ADDENDUM #4

Will County Health Department
BID PACKAGE #3 – MEP/Finishes/Carpentry/Glazing
December 6, 2018

RFI LOG
Will County Health Department
Bid Package #3 Addendum #4 12/6/18

PLAN DETAIL
SCALE: 1 1/2" = 1'-0"

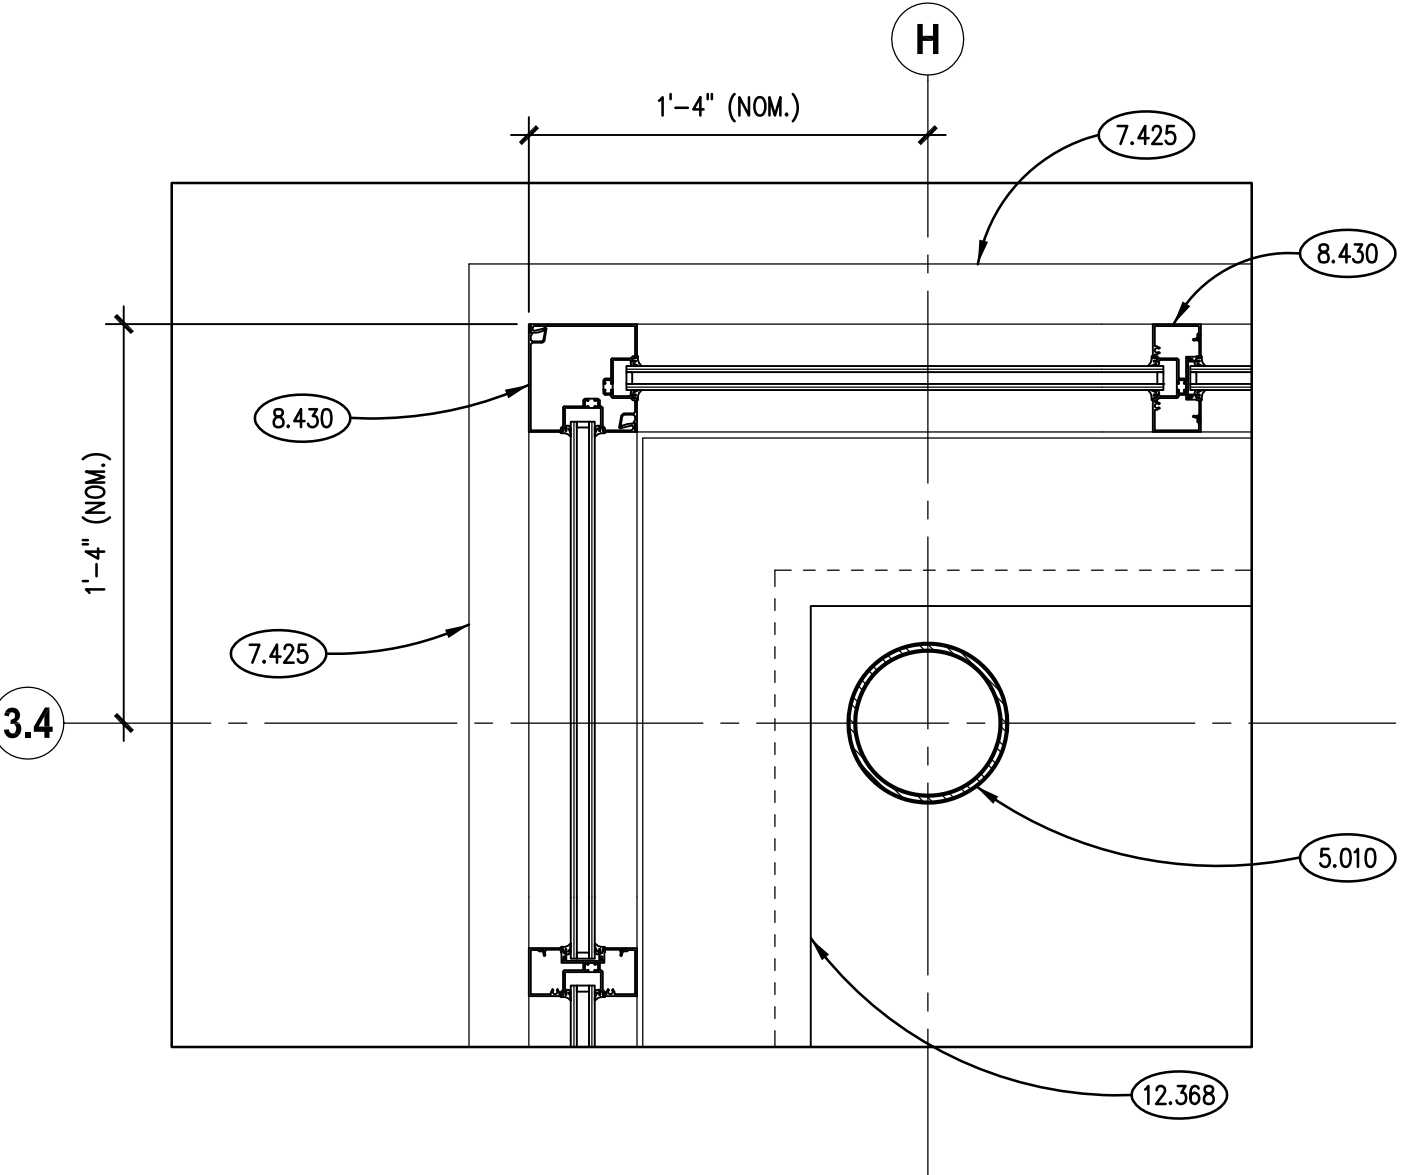
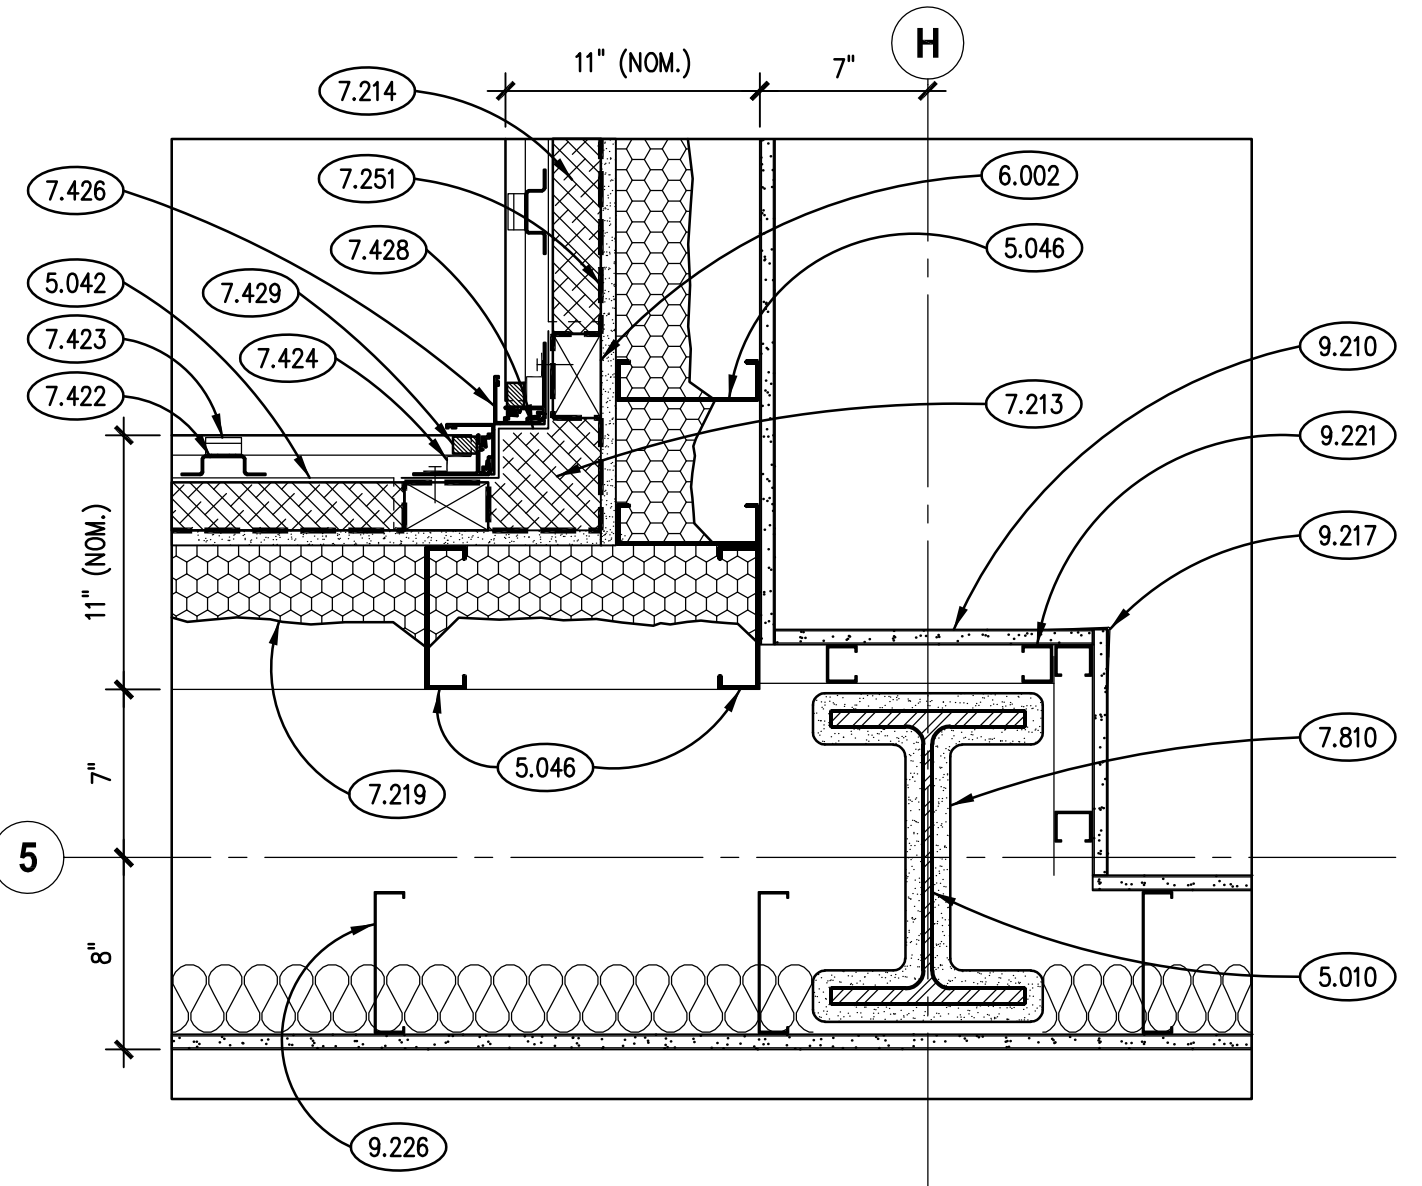
| BP3-060 | Addendum #4 | 6) See detail 1/A1001 for typical interior partition to exterior wall intersect. Keynote 9.213 indicated ½" cement board approx. 1-4"wide behind each location but the hatch width appears to be wider than ½". Should this material be roxul insulation or is the intent to run a strip of ½" cement board full height at those locations? | Detail will be revised by BP#3 - Addendum #4. Keynote will be revised to read 7.213 pointing to the roxul insulation. It is roxul tight behind all intersection walls to the outside wall assembly. Typical all outside walls. | R |

- A. Details 1 & 3: Revise Keynote 9.213 to read 7.213. Refer to attached Sheet A1001 revision cloud #11.

M311

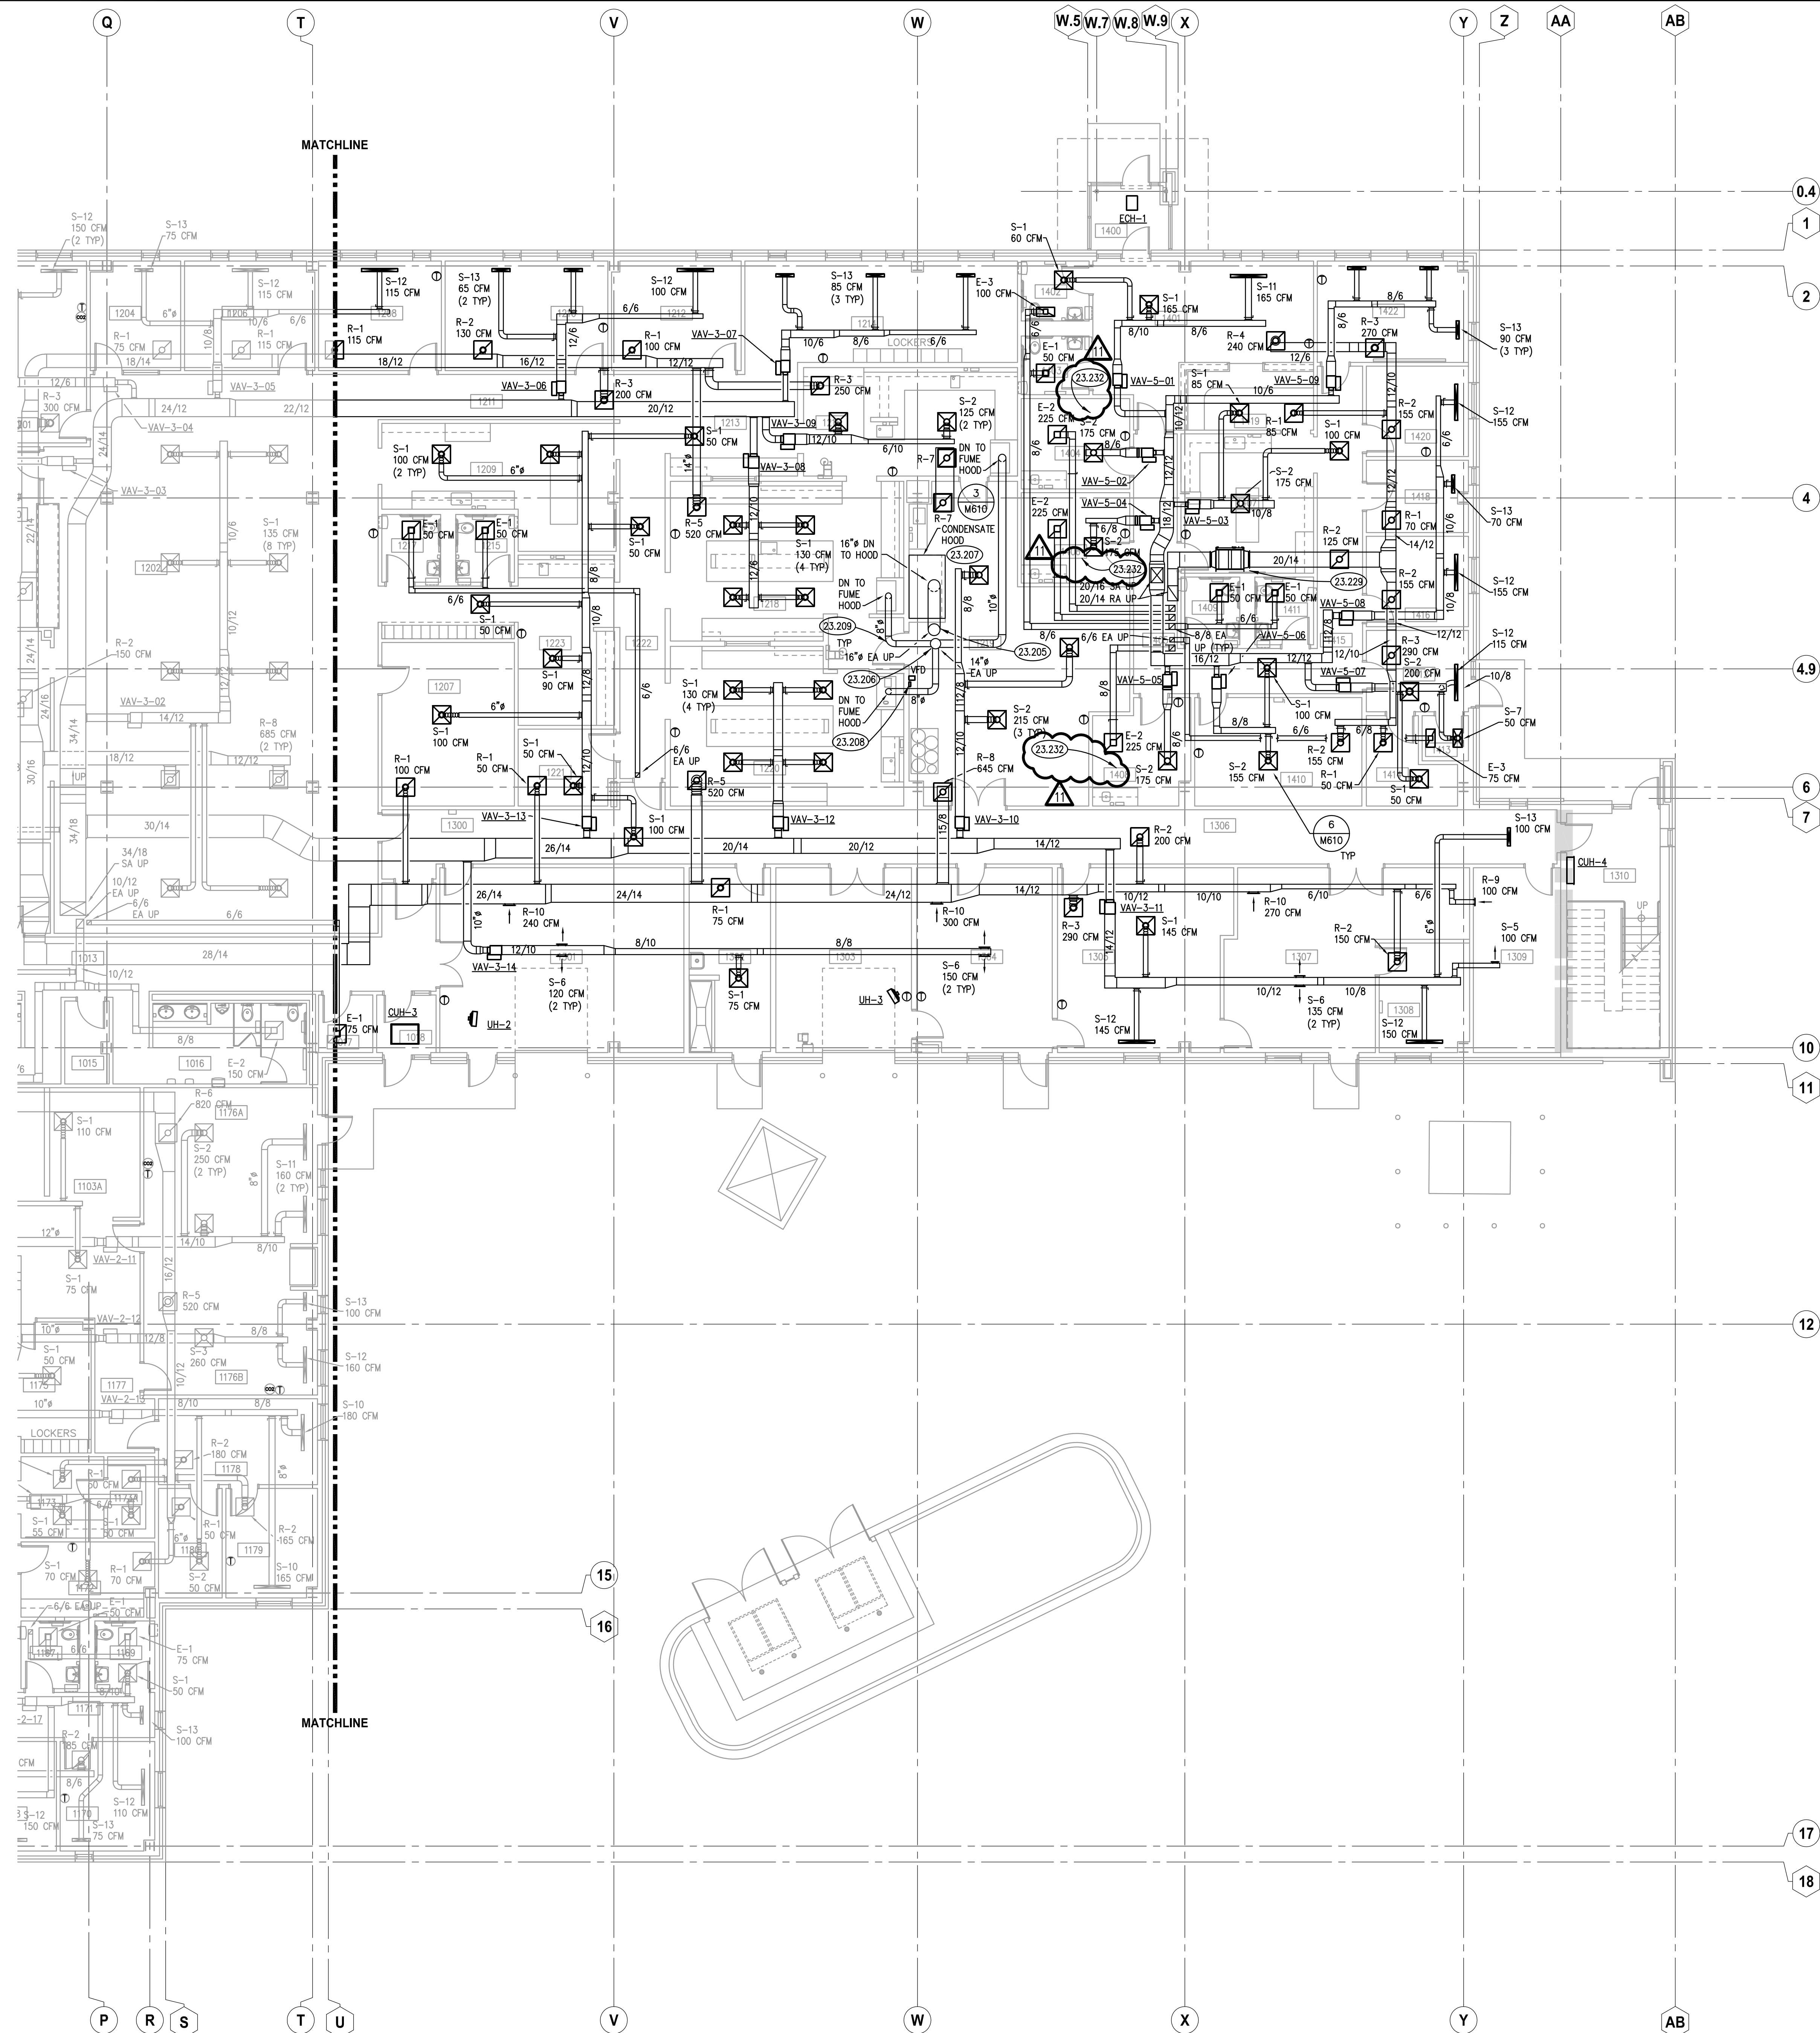
2.09 DRAWING M311 - PARTIAL FIRST FLOOR VENTILATION PLAN - AREA 'A'

SHEET TITLE
PARTIAL FIRST
FLOOR
VENTILATION PLAN
- AREA 'B'

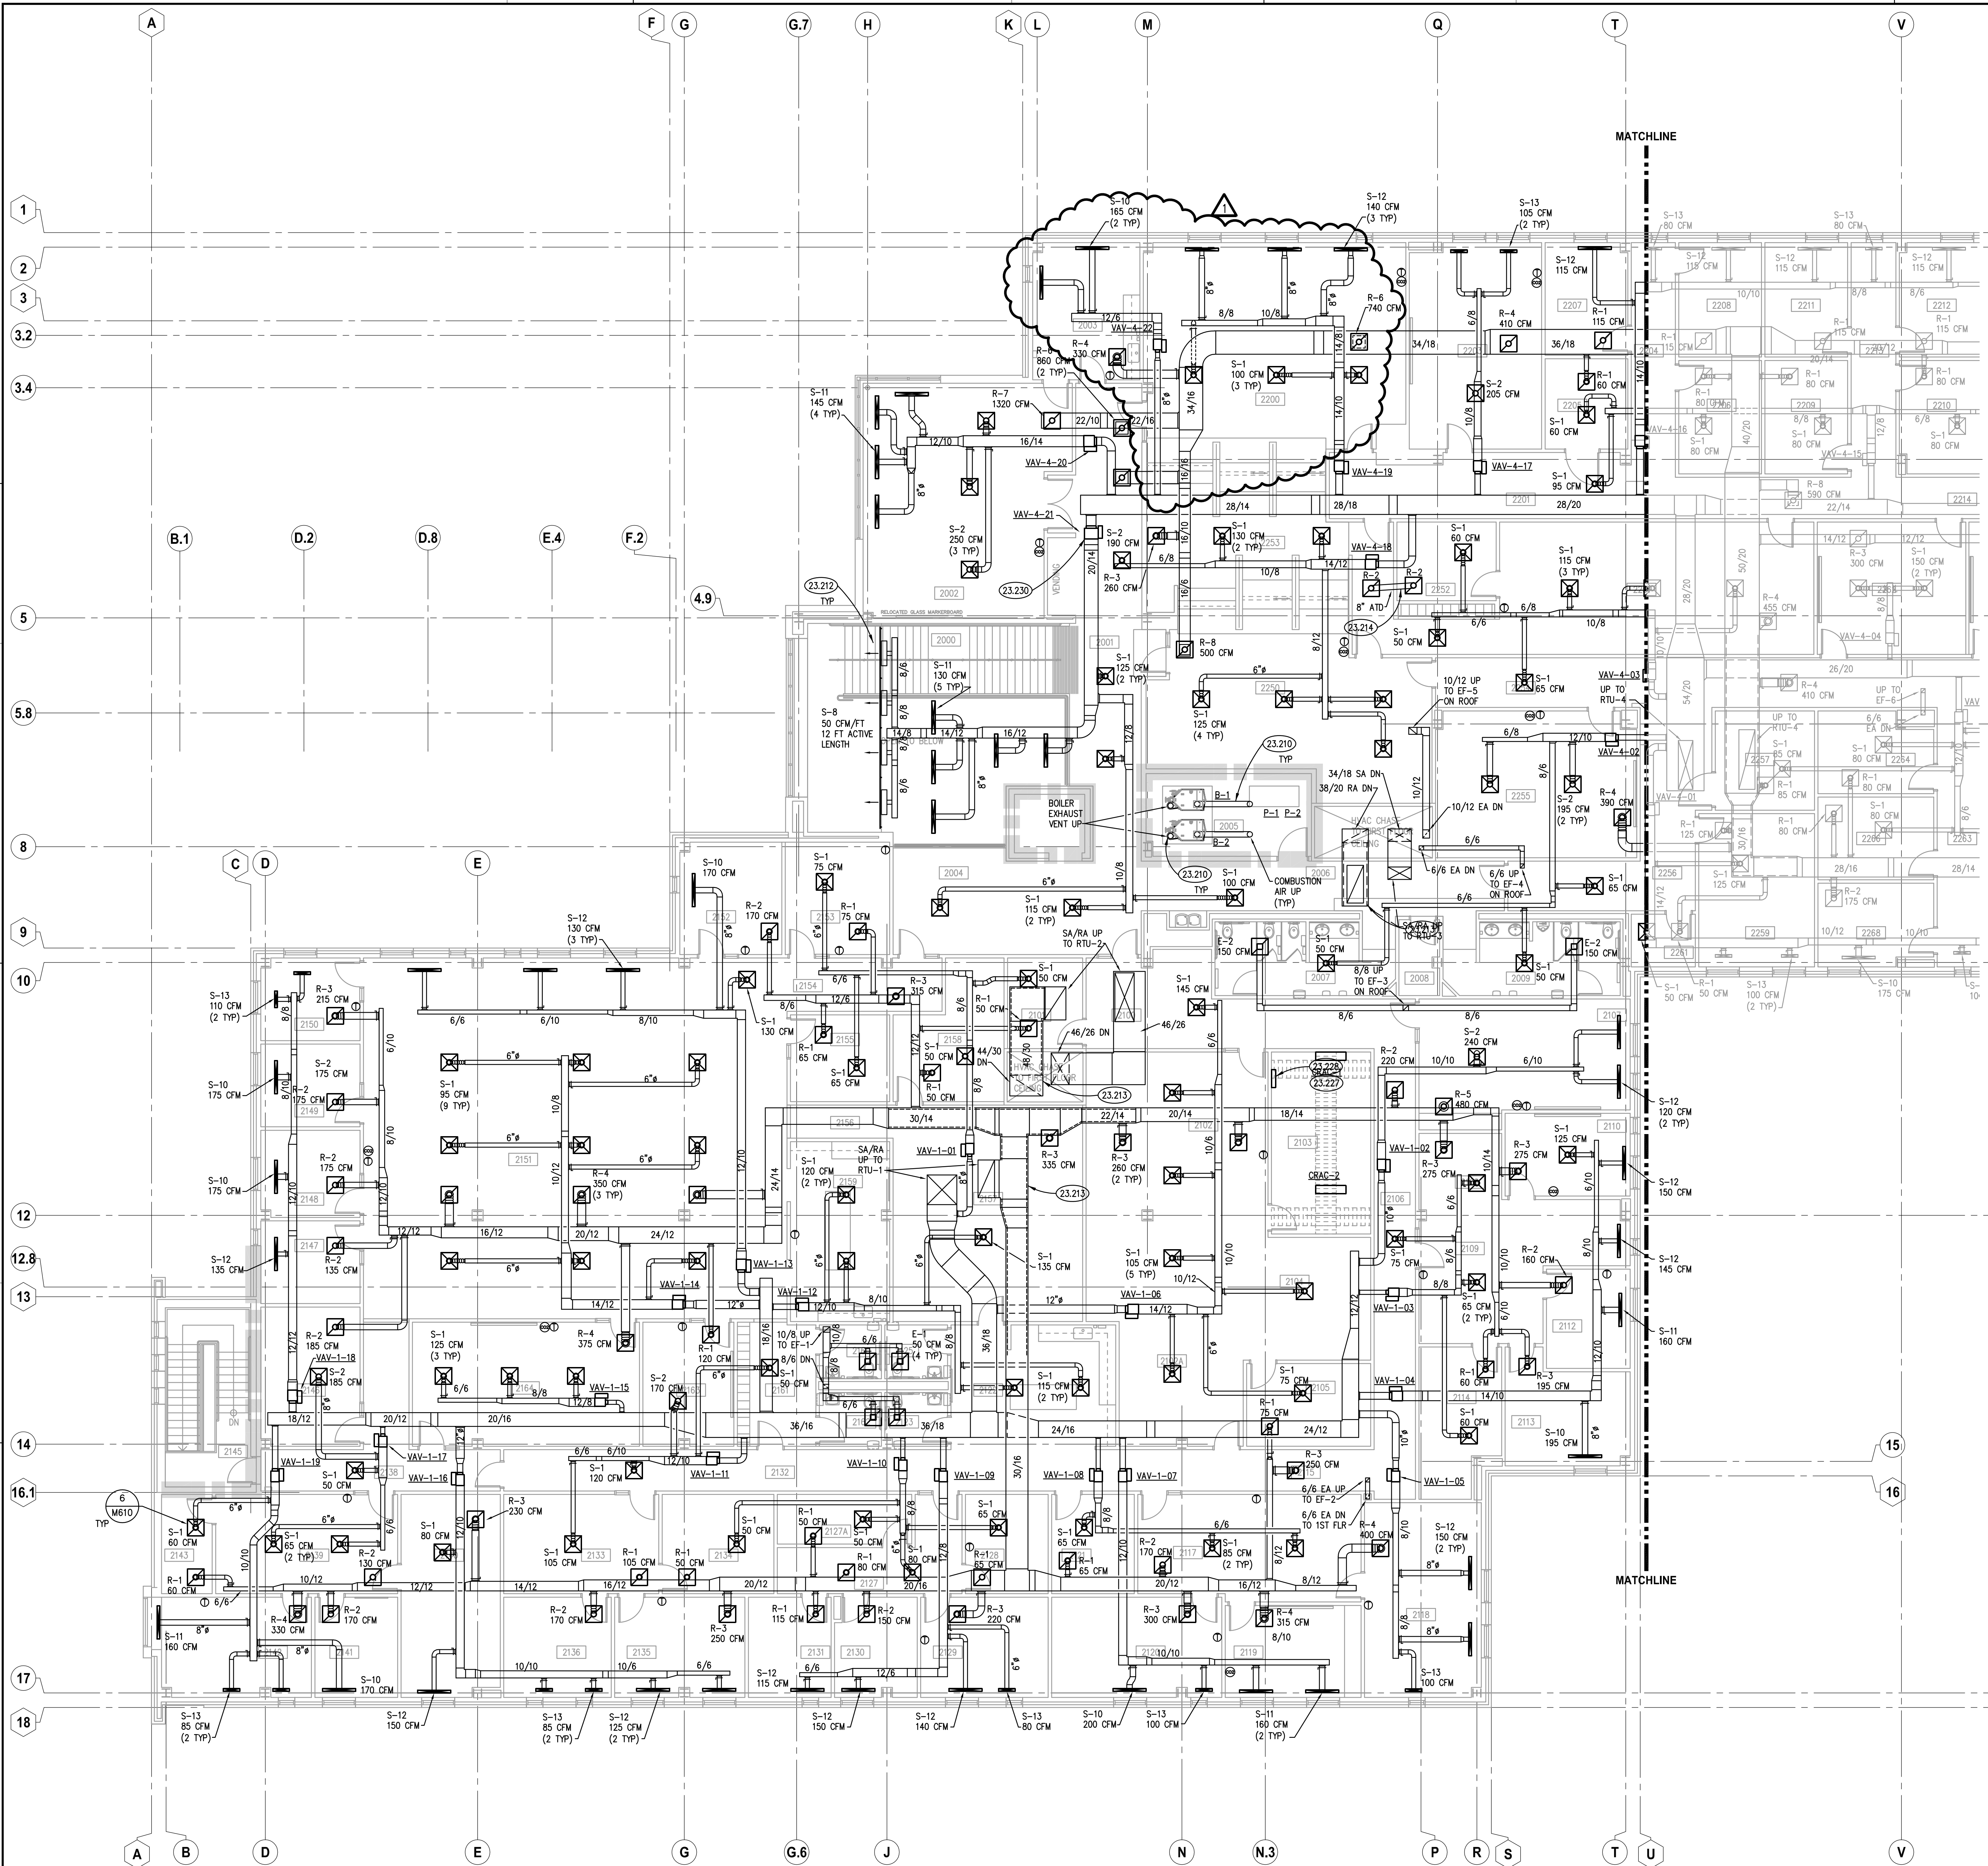
2.10 DRAWING M312 - PARTIAL FIRST FLOOR VENTILATION PLAN - AREA 'B'
